Cedar Creek WWTP Improvements

Project No. 24022

ADDENDUM NO. 3 TO THE CONTRACT DOCUMENTS

SHEET NO. 00G400

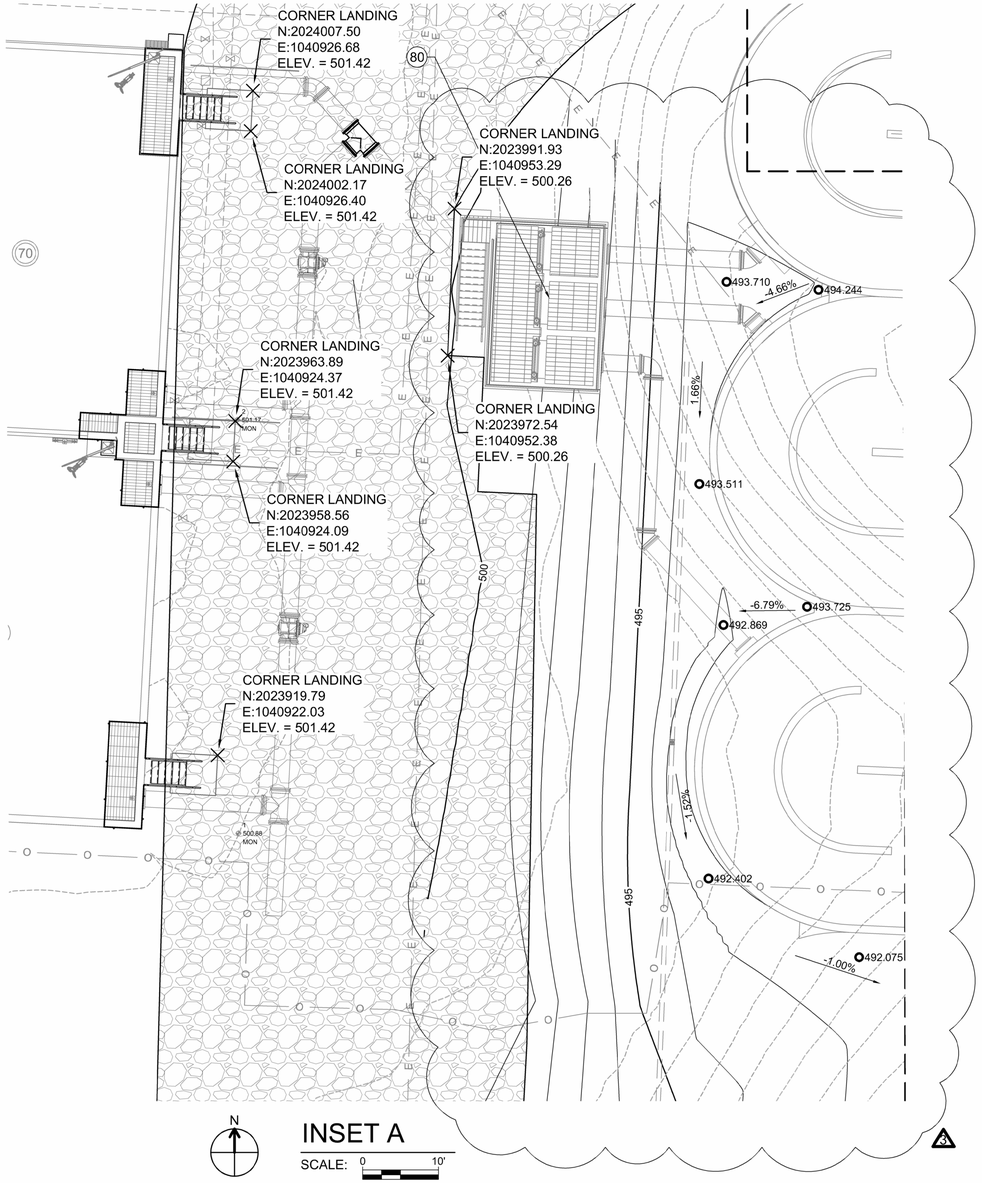
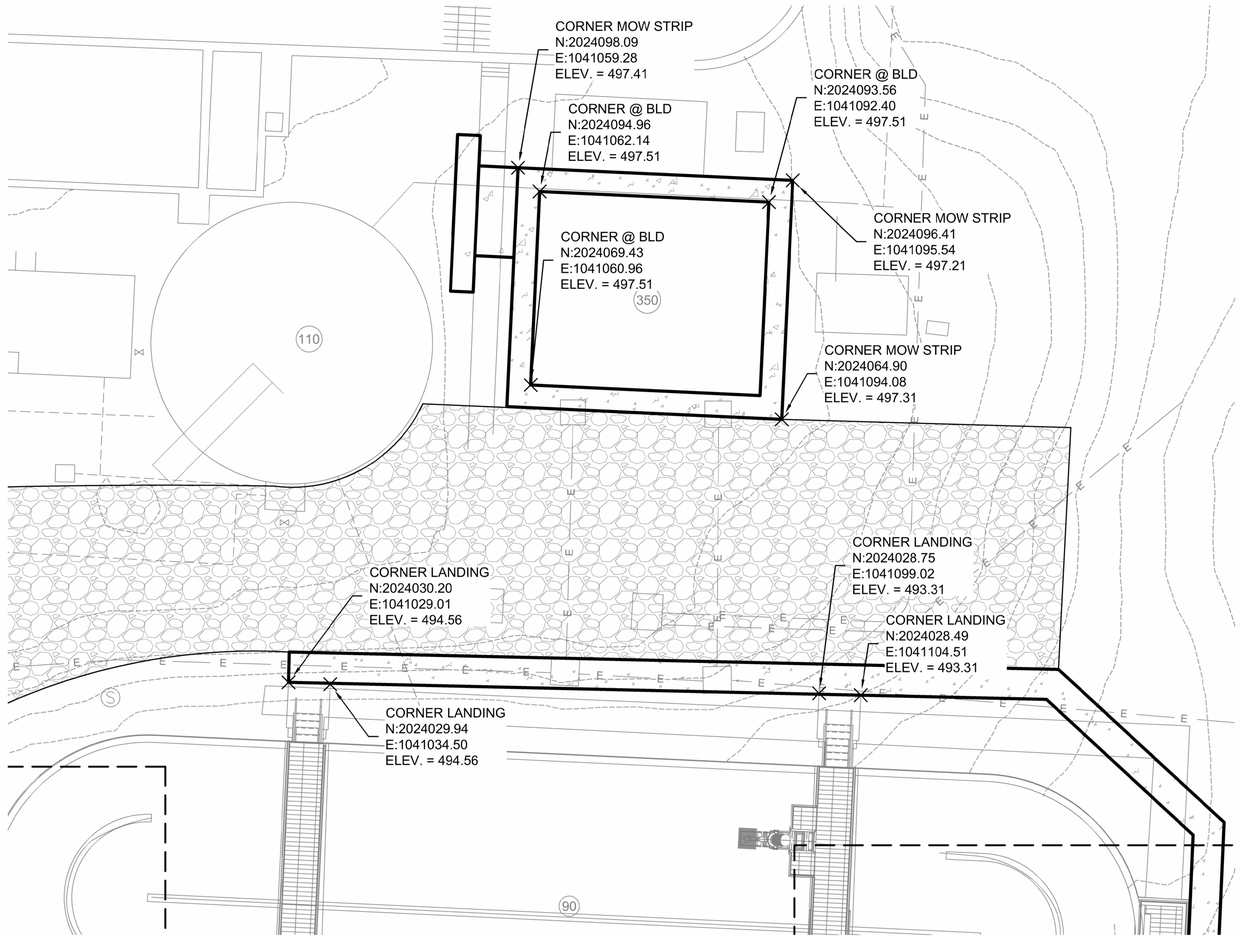
REV. NO.	DATE	DRWN	CHKD	REMARKS
3	5/22/26	MAB	BNW	ADDED CONSTRUCTION LAYDOWN AREAS

SHEET NO. 05C103

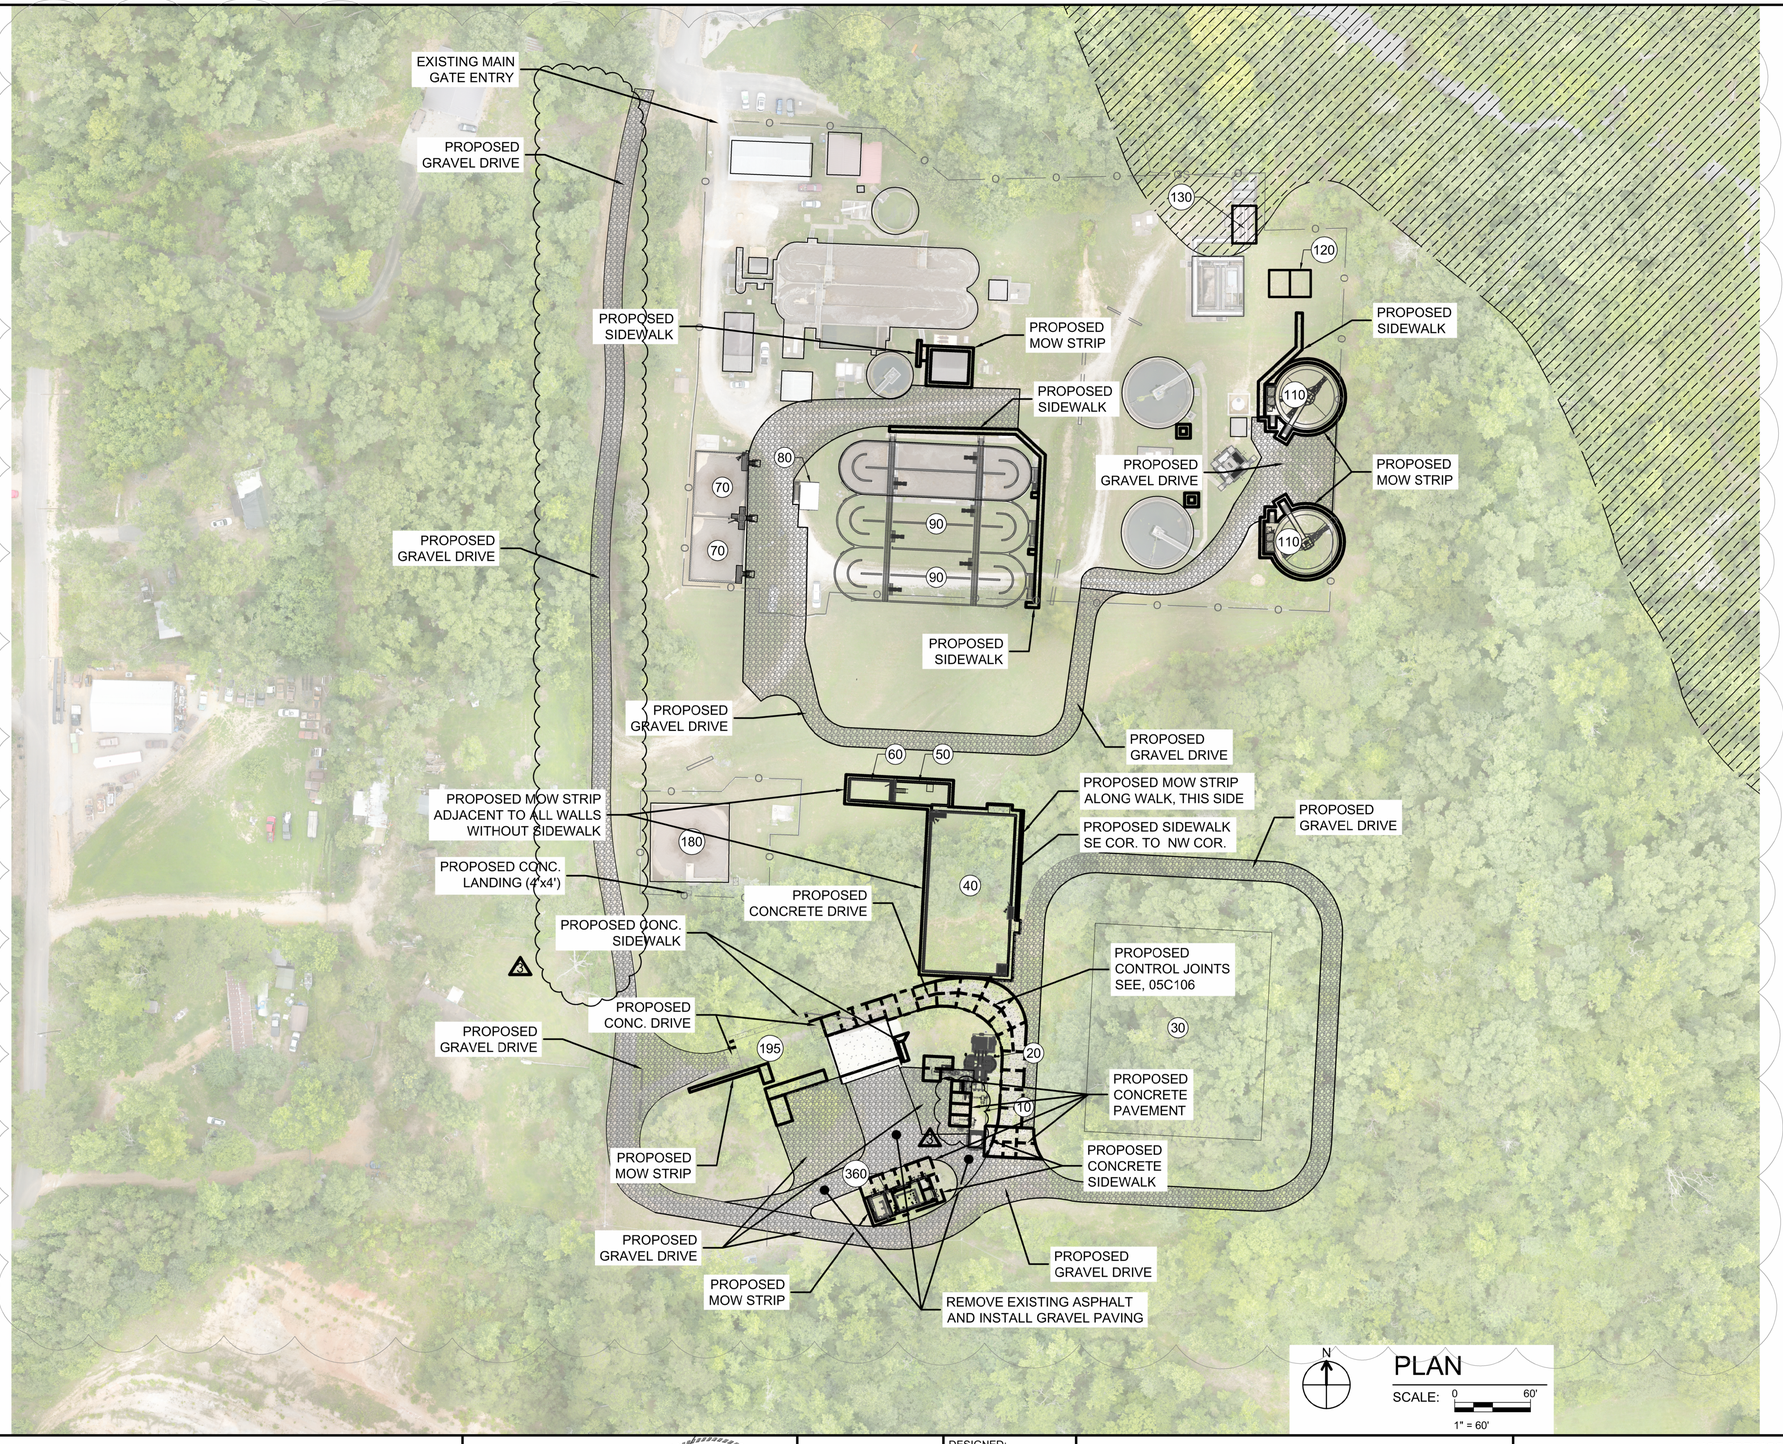
REV. NO.	DATE	DRWN	CHKD	REMARKS
3	5/22/26	MAB	BNW	REVISED GRADING ALONG WEST END OF DITCHES FOR CLARIFICATION

SHEET NO. 05C109

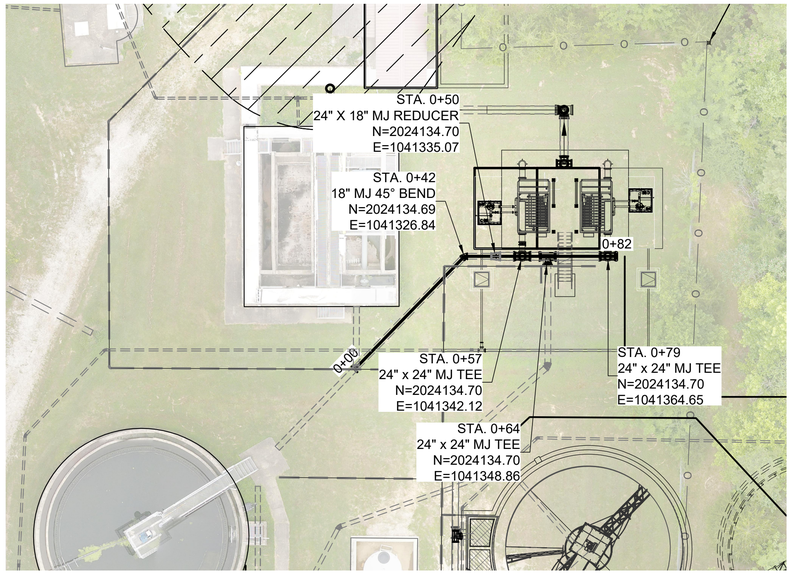
00M900, 10M101, 10M302, 20M101 concrete paving (i.e. dumpster pads) will be updated to reflect concrete paving as shown on 05C109 in the conformed set.

REV. NO.	DATE	DRWN	CHKD	REMARKS
3	5/22/26	MAB	BNW	GRAVEL DRIVE SHOWN ALONG WEST, CONCRETE PAD UNDER DUMPSTER
2	5/13/26	MAB	BNW	CLEAN UP SHEET TO ONLY INCLUDE SURFACE REQUIREMENTS

SHEET NO. 05C333

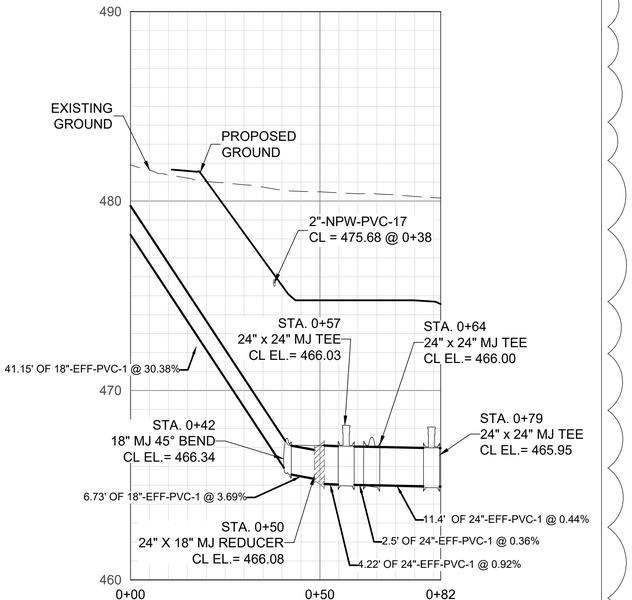
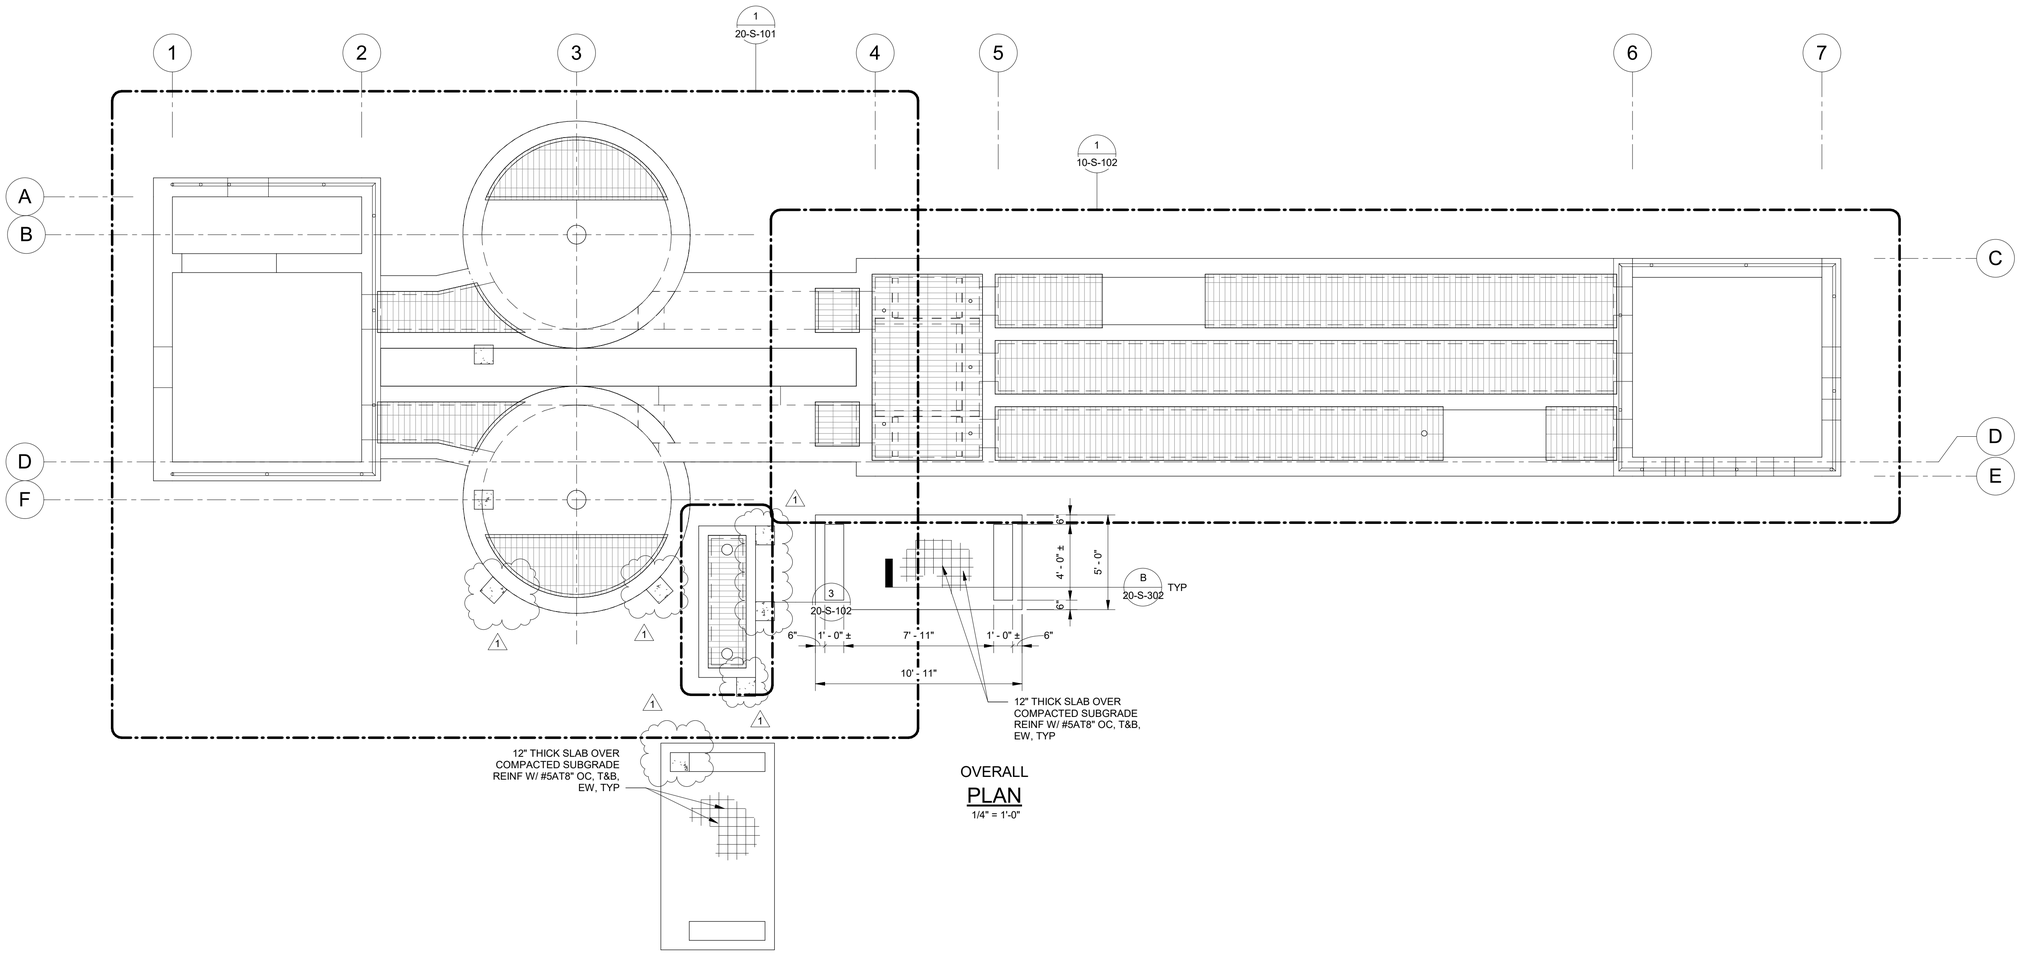
45	What is happening on sheet 05C333 (existing clarifier effluent to new Tertiary Filters)? Are we intercepting the line that went to the existing Tertiary Filters, effectively taking the existing filters out of service or is the intent to install a wye in order to run both the new and existing filters? Looking at 130-S-101 (UV structural mods) it appears that the existing filters will in fact be taken off line.	The intent is that when the new connection is made that secondary clarifier effluent will only travel to the new tertiary filters thus taking the existing filters out os service.	-
46	If the existing Tertiary Filters are abandoned, to what extent should the buried piping entering and exiting be demolished? Only what’s required to make new piping tie-ins? If the existing piping is to be left abandoned in place, is a concrete plug on the cut ends a satisfactory way to seal them off for burial and abandonment?	MJ plug with concrete backing for abandonment is sufficient. Abandoned in place is sufficent.	-

REV. NO.	DATE	DRWN	CHKD	REMARKS
3	5/22/26	MAB	BNW	CORRECTED LABLE TO READ 24" X 24" MJ TEE & REMOVED TEE @ 0+65

SHEET NO: 80M101

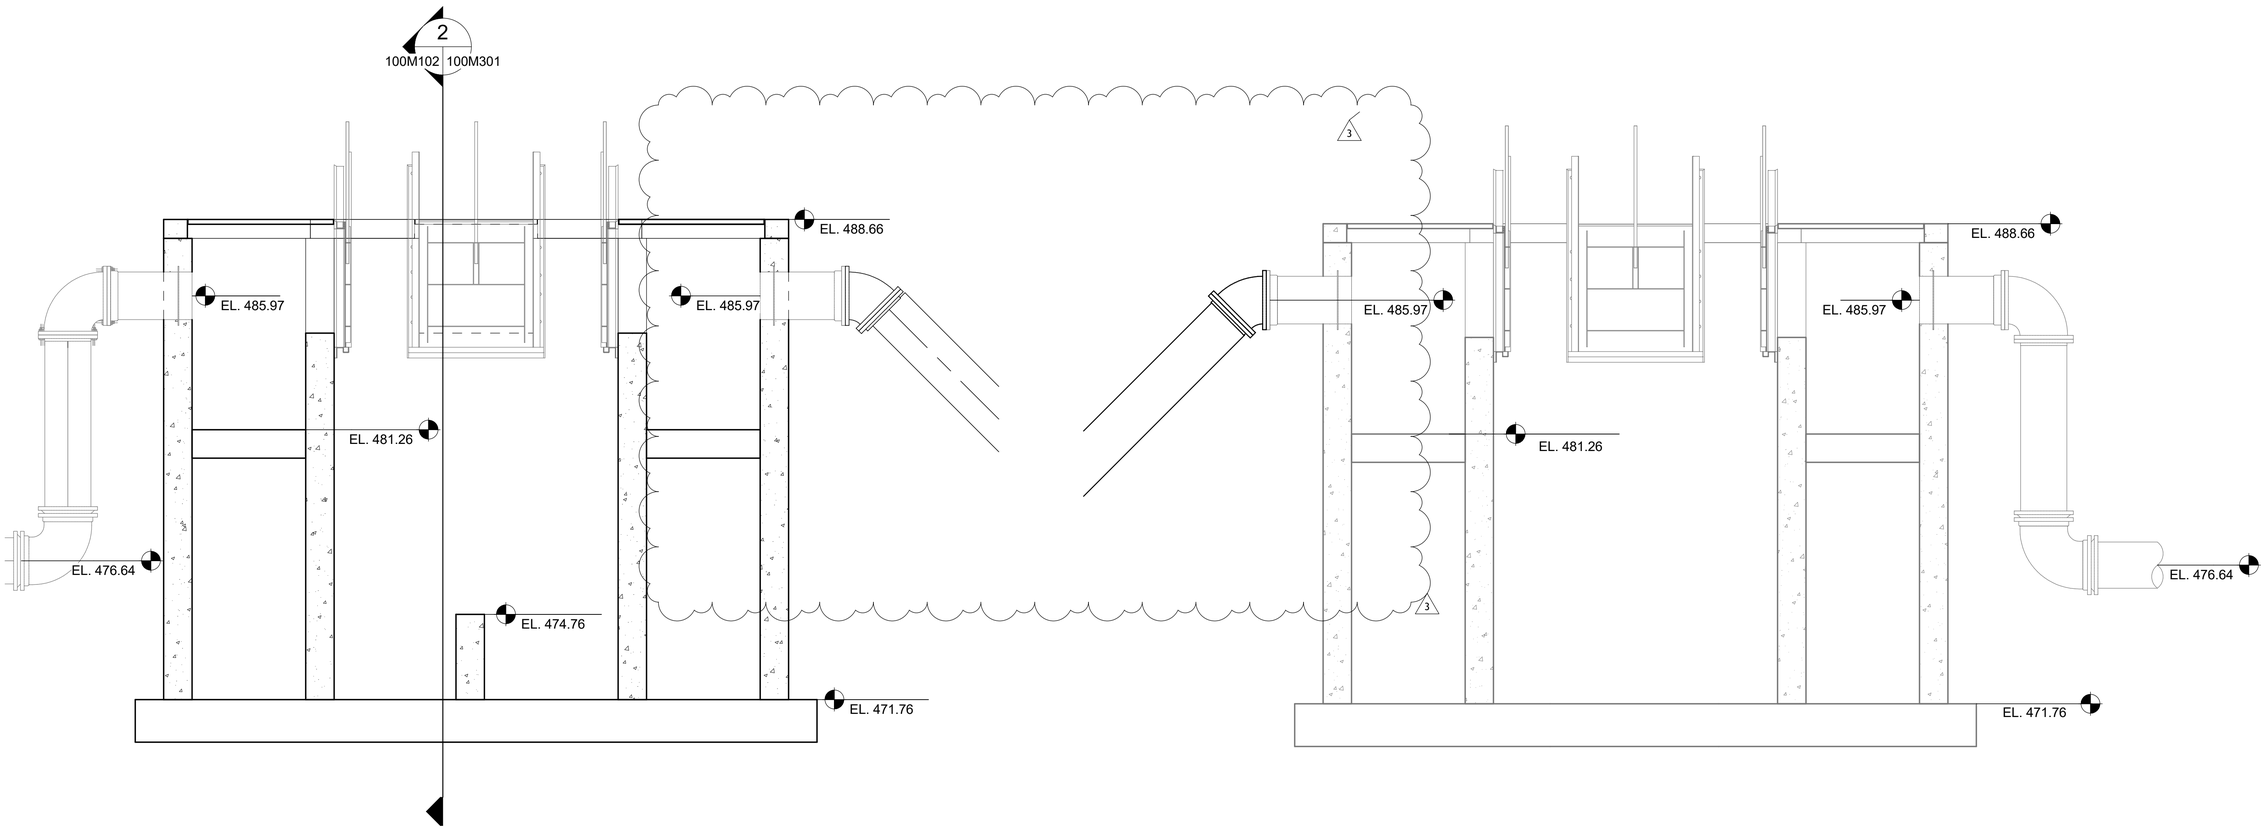
REV. NO.	DATE	DRWN	CHKD	REMARKS
3	Date 3	MAB	BNW	REVISED 24"-MLSS-PVC-8 TO MATCH CIVIL PLAN
